To: Design Review Board
From: Angela Ruggeri, Senior Planner
Date: November 28, 2016
File No.: DRV16-02450
Subject: **434 KIRKLAND WAY MIXED USE PROJECT
DESIGN RESPONSE CONFERENCE**

Re: 434 Kirkland Way – Mixed Use 16-0217
Subject: Design Response Conference Design Guidance Letter

DESIGN REVIEW
DESIGN RESPONSE CONFERENCE
SUBMITTAL DATE: OCT 5, 2016
PRESENTATION DATE: DEC 5, 2016

1. PROPOSED PROMENADE SECTION TYP.

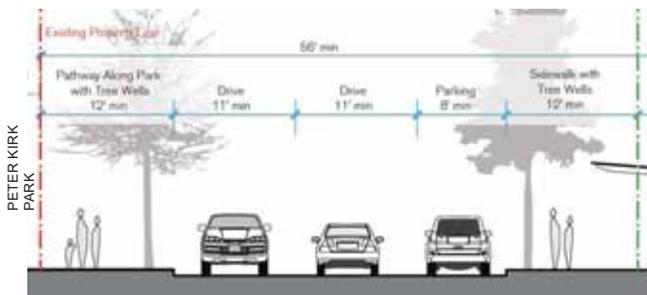
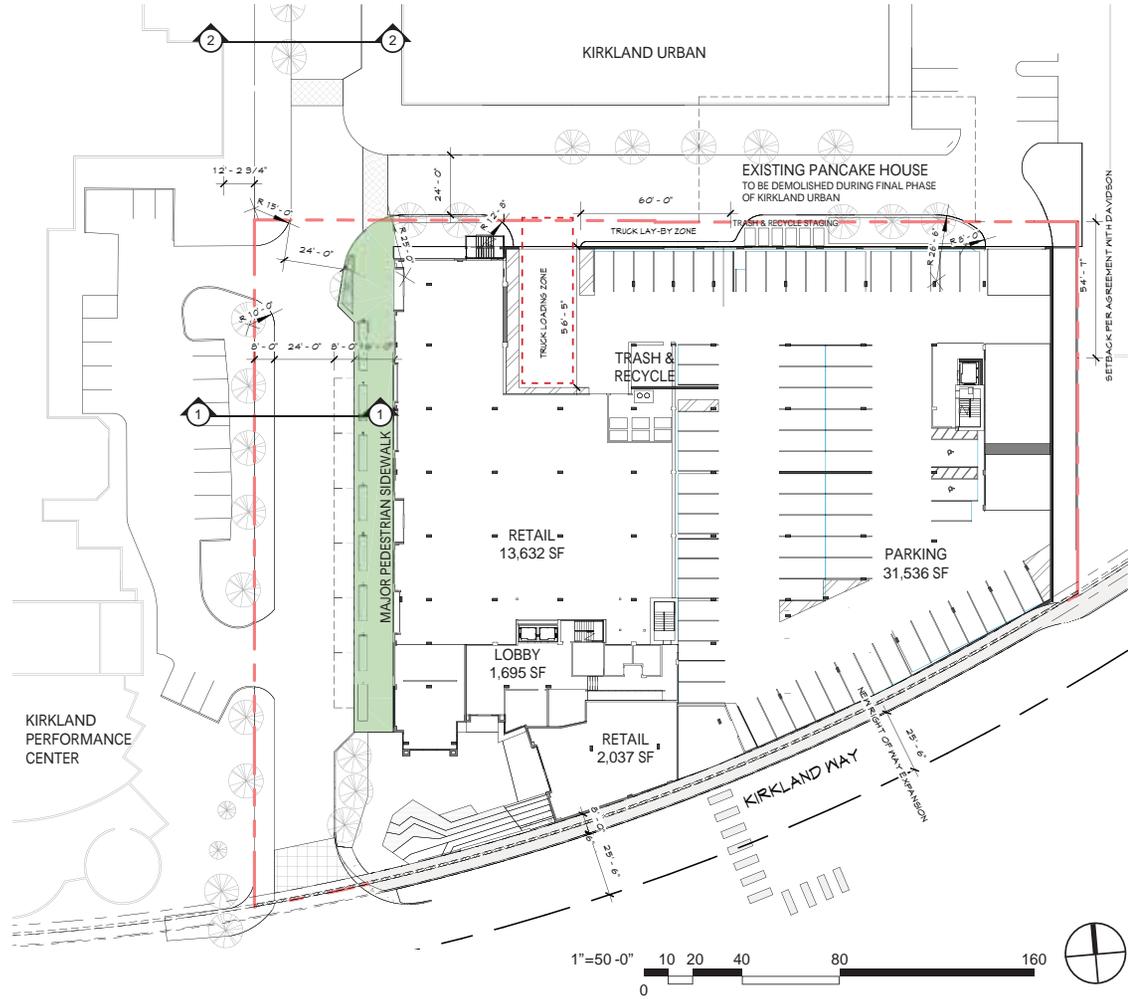
The project will seek to gain permission to reduce the walkway at the west side of the easement that adjoins Peter Kirk Park down to 8-foot. Reducing the sidewalk at the west side of the easement will allow us to gain 4-foot at the east side adjacent to the proposed retail. This new 16-foot walkway next to the retail will allow more enhanced promenade at the retail side for seating, landscapes and other amenities. See landscape plan for further clarification of proposed hardscape design.

PERSPECTIVE - VIEW NE FROM PLAZA ON KIRKLAND WAY

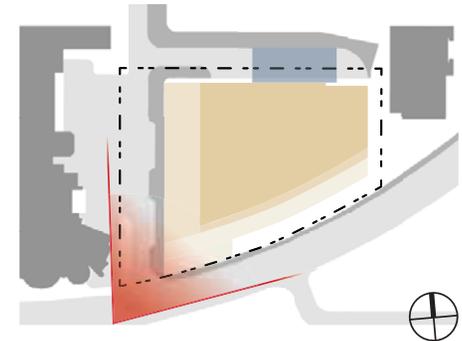
- a. The treatment of the southwest corner of the building, above the plaza, is key. Explore articulation and fenestration in this area.
 - Overall massing and configuration at the SW corner has been updated to express more balanced tiers of upper level units to retail at grade, with a vertical design curtain wall climbing up to the penthouse level. The Southern most unit facing Kirkland Way at the west end now perches above the retail. Design includes a main level lobby entry at the ground level between the two retail fronts. This lobby entry is framed with pilasters and prominent entry canopies.

The design review board expressed concerns about the southwest corner. The way that the protruding retail comes together with the wedding caked shaped masses at the upper levels is a significant key to successfully configuring the aesthetics that really compliments the corner of the site. As these exhibits show we have taken the corner, re-sculpted the upper levels and brought the forms together to celebrate the corner, opening the mid segment for the main entry lobby and terracing the building form back from a epitomizing corner window wall feature which extends through all levels of the building.

1. PLAZA SECTION

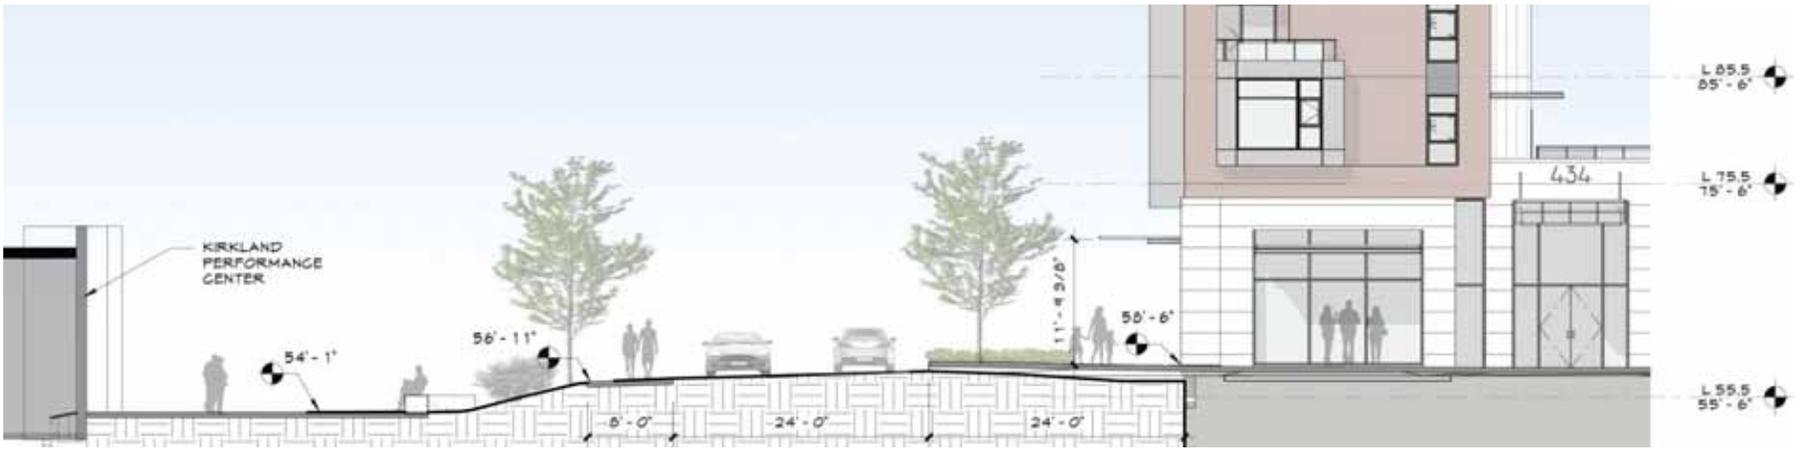
- Provide more information on the inner plaza and explore ways to make it more open/ visible from site.
- Design the SW corner to acknowledge its importance as a pedestrian gathering place and entry into the site (explore increased setback of the retail at that location).

The public plaza at the southwest corner will include a water feature and seating to define an art piece for the pedestrians to enjoy. Trees and shrubs will also work in conjunction with the plaza features to contribute to the community as the space will truly come alive in multi-purpose use, such as mini-outdoor performing or interactive playful gathering space.

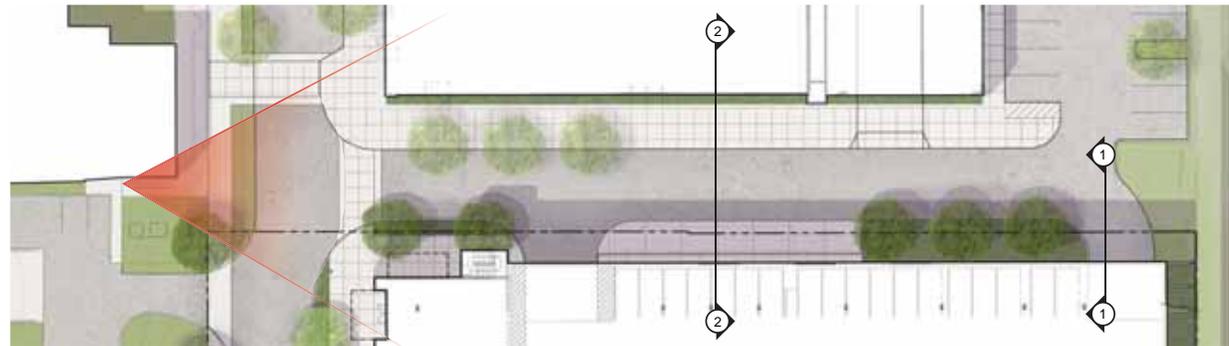
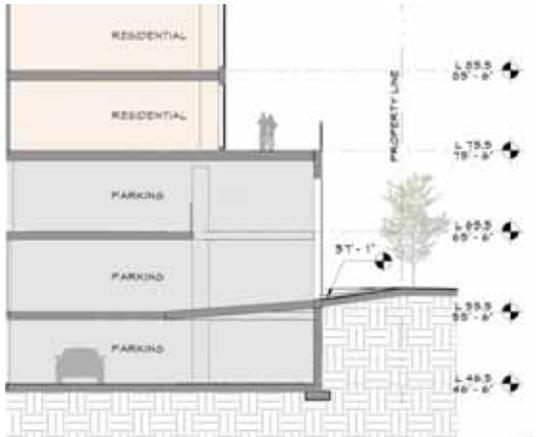
a. The DRB was generally supportive of the proposed promenade connections to Kirkland Urban, but the design must provide a smooth transition along the Promenade from Kirkland Urban to Kirkland Way.

- The proposed project maintains the intent of the architectural finish for the walking pavement. The material of the crosswalk and the sidewalk will be consistent with the design guidelines.

NORTH ELEVATION

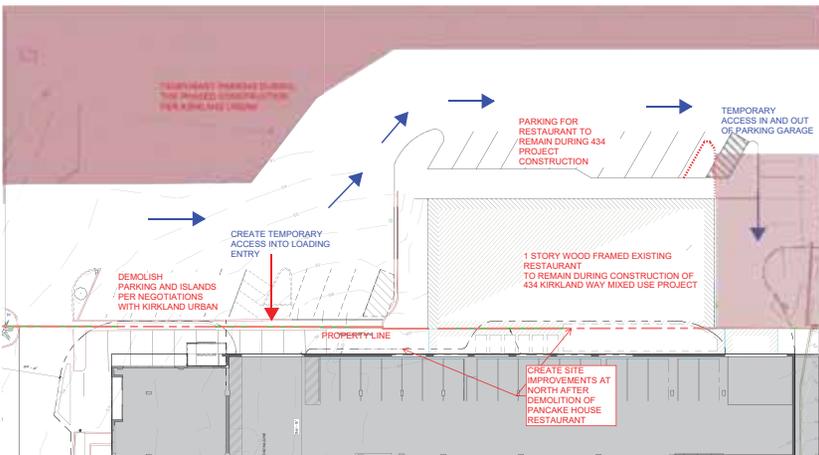
b. Provide more detail on the building modulation, particularly for the north elevation.

- North façade has been updated to incorporate modulation horizontally and vertically. Brick facades for the townhomes over retail articulates recessed planes and balconies using either metal or fiber cement panels. Modulation at the residential floors has been expressed with vertical and horizontal window bays. Vertical bays are expressed with the use of different color panels and window configuration. The horizontal bays span multiple units, include a row of fenestration and serves as balconies.

RELATIONSHIP TO EMERALD OFFICE BUILDING

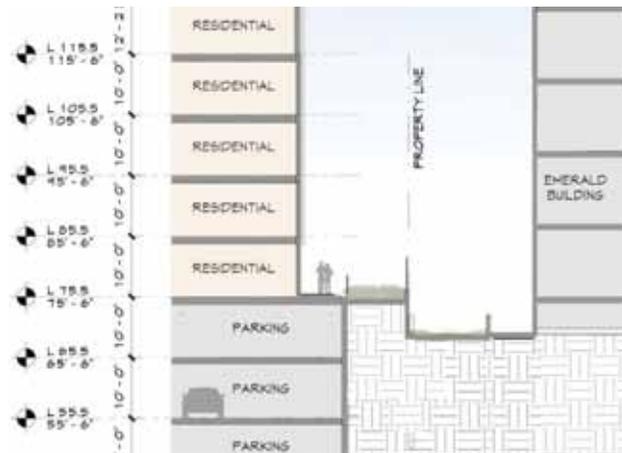
DRB had concerns about the transition to the property at the east as well as dealing with the steep berm at the northeast corner of the site.

As the exhibits and sections show, terraced landscape beds will rest within concrete walls as it extends east up to the neighboring keystone wall. The keystone wall remains intact and the terrace landscape bed acts as a security measure to ward off trespassing.
